**HINCKLEY NATIONAL  
RAIL FREIGHT INTERCHANGE**

**Aston Firs Technical Note [Appendix 4 (E) Road Safety  
Audit 1 (RSA1)]**

STAGE 1 – ROAD SAFETY AUDIT

REPORT REF: 24-1363.01-RSA1C

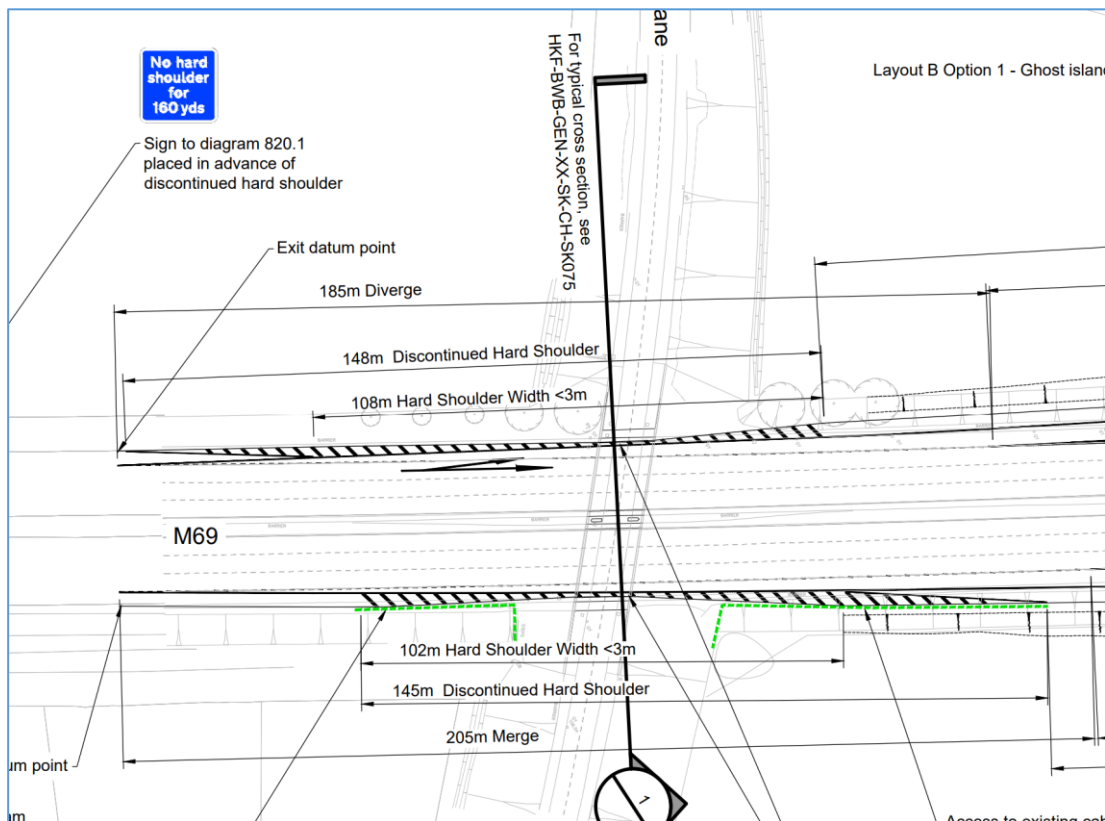
1.6 The audit also comprised of a desk-top study where all documents and plans provided by the Design Team were reviewed. A list of these can be found in Appendix A. The auditors have been made aware of two departures from design standards. Whilst the submission for these departures remains in preparation, the two departures are:

- Proposed section of discontinuous hard shoulder of new south facing diverge slip at M69 J2; and
- Proposed section of discontinuous hard shoulder of new north facing diverge slip at M69 J2.

- 1.8 Having reviewed the implications of these departures on the safety of the network, whilst amendments to the existing vehicle restraint system will be required to accommodate the works no indication is shown on plan of this. It will be essential that working widths and containment levels past identified hazards are maintained and that adequate protection is afforded to maintenance and emergency workers operating in this area. The formal departures report will be awaited before commenting further.

#### M69 Junction 2 / B4668 Roundabout Terminal Junctions

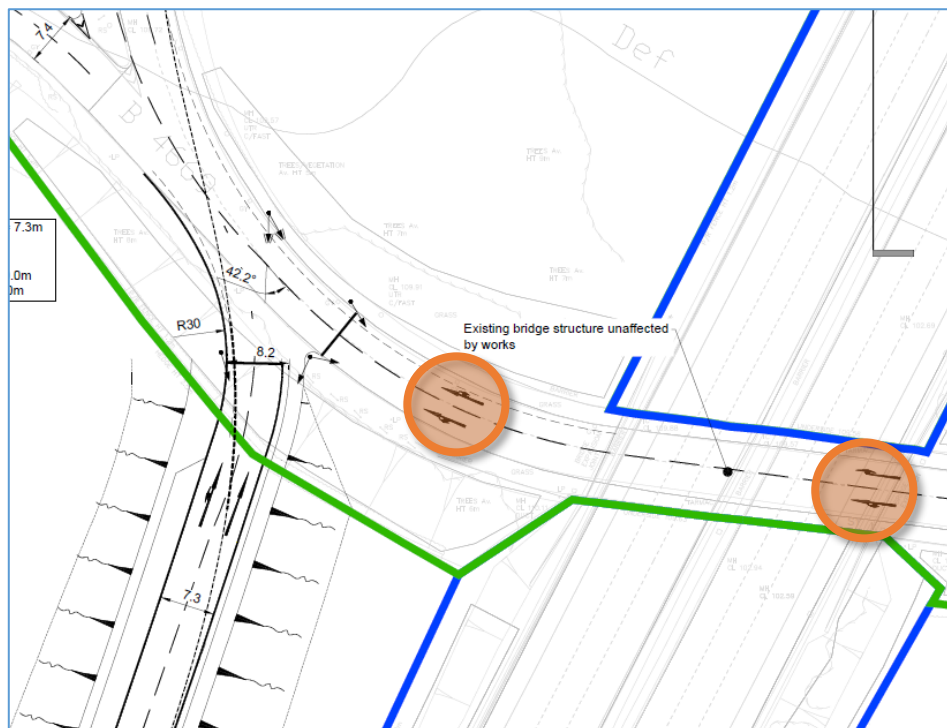
Location: M69 J2 southern circulatory carriageway.

Summary: Confusing road markings risk side swipe type collisions.

Around the southern carriageway of the circulatory the lane destinations show an “ahead” and a “right turn” arrow. However, approaching the junction and on the approaches before this point, “ahead” and “ahead and right” arrows are shown. This could lead to late lane changes, sudden and unexpected braking and side swipe type collisions due to driver confusion and late decision making as a result of confusing and misleading lane destinations.

Location: M69 southbound approach to the new signalised junction.

Summary: Poor forward visibility of signals risks late braking and junction overshoot type collisions.

The southbound off-slip approach to the proposed signals at Junction 2 has a significant vertical and horizontal alignment change on the approach to the current Give-Way line. There is a concern that, given these changes and the existing signing infrastructure, that forward visibility towards the signal heads will not be provided for vehicles.

Location: M69 southbound approach to the new signalised junction.

Summary: Amended stop line position risks loss of control type collisions and shunts.

The provision of the stop line at the signalised off-slip means that the existing high friction surfacing will be substandard in length. This could lead to loss of control collisions or shunts involving late breaking vehicles.

Location: M69 southbound approach to the junction.

Summary: Amended signing missing diversion information risks late manoeuvres and shunts / side swipe collisions.

Whilst it is appreciated that the sign design is at a preliminary stage, the proposed signing eliminates / does not include the existing diversion route symbol. This could result in confusion for drivers following the diversion route, resulting in late lane changes and shunt type collisions.

It is recommended that the markings are amended so that they are consistent with the available movements around the southern half of the circulatory and on the westbound link road exit.

It is recommended that the signals are located and designed, including raised poles and/or gantry signals if needed, so as to provide adequate forward visibility for approaching vehicles. Furthermore, it is recommended that the signing on the approach is amended so as not to pose an obstruction.

It is recommended that, as part of the detailed design, the length of high friction surfacing is amended to consider the amended stop line position.

It is recommended that, as part of the detailed design, the diversion route symbols are included where appropriate.
